DESCRIPTIVE REPORT

Sheet No. T5051

South Shore of Long Island.

REPORT ON REVIEW OF SHEET

ALUMINUM CONTROL SHEET

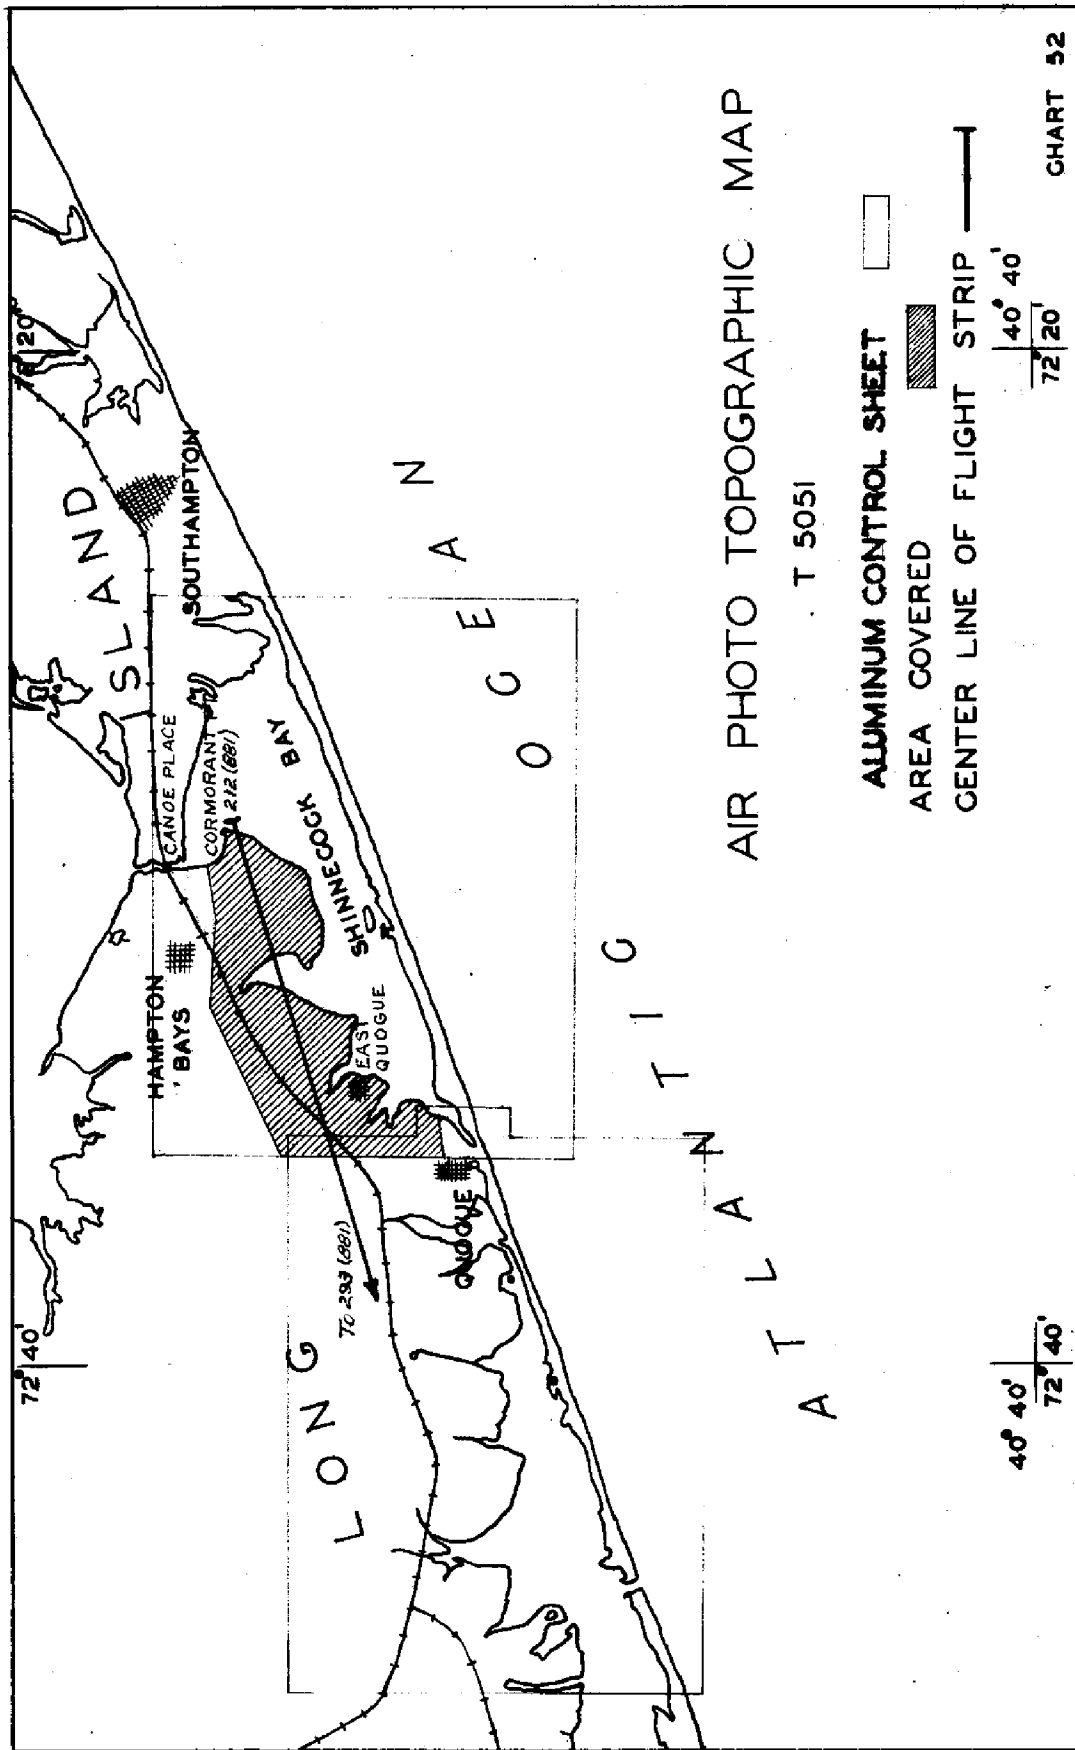
In regard to the last paragraph under CONTROL, (A) Sources, in the preceeding COMPILER'S REPORT, as the blue will not photograph during the photo-lithographic process no record of these topographic control signals (banners and flags) will appear on the finished sheet.

If it is the desire of the Chart Section to have these shown, they may be indicated in red ink with the usual circle and topographic name; this may best be done by draftsmen in the Washington Office as they will have all the data at hand.
